Item 1
**29A Boyce Street, Ryde - LDA2021/0155
 Sports field lighting to Gannan Park**
Report prepared by: Consultant Planner

**City of Ryde
 Local Planning Panel Report**

DA Number	LDA2021/0155
Site Address & Ward	29A Boyce Street, Ryde NSW 2112 Lot 36 DP 249927 & Lot 23 DP 259418 East Ward
Zoning	RE1 Public Recreation R2 Low Density Residential Zone E2 Environmental Conservation
Proposal	Sports field lighting to Gannan Park including the installation of four (4) 22m high light poles and associated earthworks. The lighting would be used for training and social sports with the proposed hours of operation being: <ul style="list-style-type: none"> • Winter (April to August): Monday to Friday - 4pm to 9:30pm • Summer (September to March): Monday to Friday - 6pm to 9pm.
Property Owners	City of Ryde
Applicant	City of Ryde
Report Author	Brendon Clendenning, Consultant Planner
Lodgement Date	12 May 2021
Notification No. of Submissions	21 submissions received in total, nineteen (19) of which were 'unique' submissions: <ul style="list-style-type: none"> • Fourteen (14) submissions in objection to the proposed development. • Five (5) submissions in support of the proposed development.

Figure 10 Submitted shadow diagrams depicting the shadow of the light pole located to the north of residential properties (yellow highlighting added)

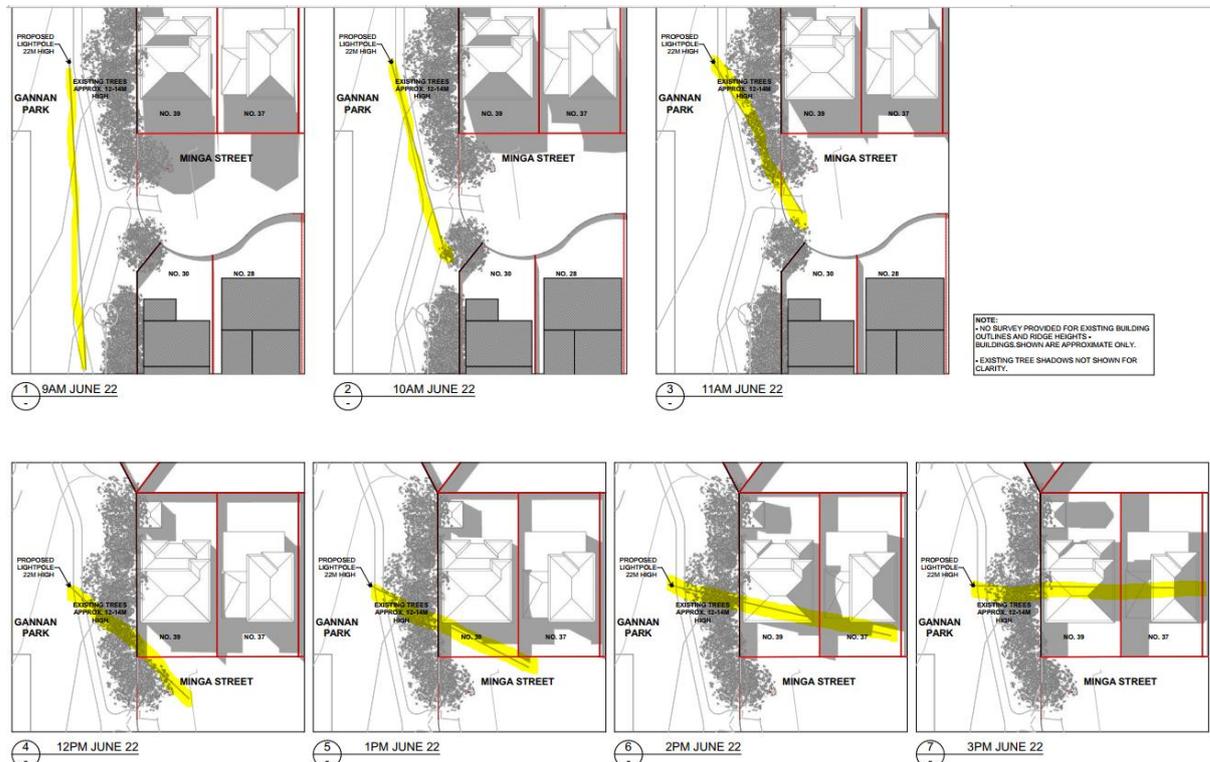
Notwithstanding, the proposal adjoins multiple residential properties, and given the proposed height of 22m, there is the potential for the development to create overshadowing impacts to adjacent properties, including private open space areas, internal living areas, and solar panels.

The applicant was requested to provide shadow diagrams to enable a consideration of the potential impacts. Of the 4 light poles, only one has the potential to cause an increase in overshadowing to the adjoining properties. This is the light pole located closest to Minga Street. The following shadow diagrams were provided and are reproduced below.

The shadow diagrams indicate some additional afternoon overshadowing to No.39 Minga Street, directly adjoining the subject site, and the property further to the south-east, No.37 Minga Street. However, the shadow diagrams also indicate that these properties will continue to enjoy compliant solar access during the morning hours, and the proposal would not create any non-compliance with the relevant provision.

The property at No.39 Minga Street contains rooftop solar panels which face north-west and north-east. There are no provisions relating to overshadowing to solar panels within the RDCP 2014. Notwithstanding, the impacts were considered and are expected to be minor, concentrated within late midwinter afternoons, and affecting only a small portion of the panels.
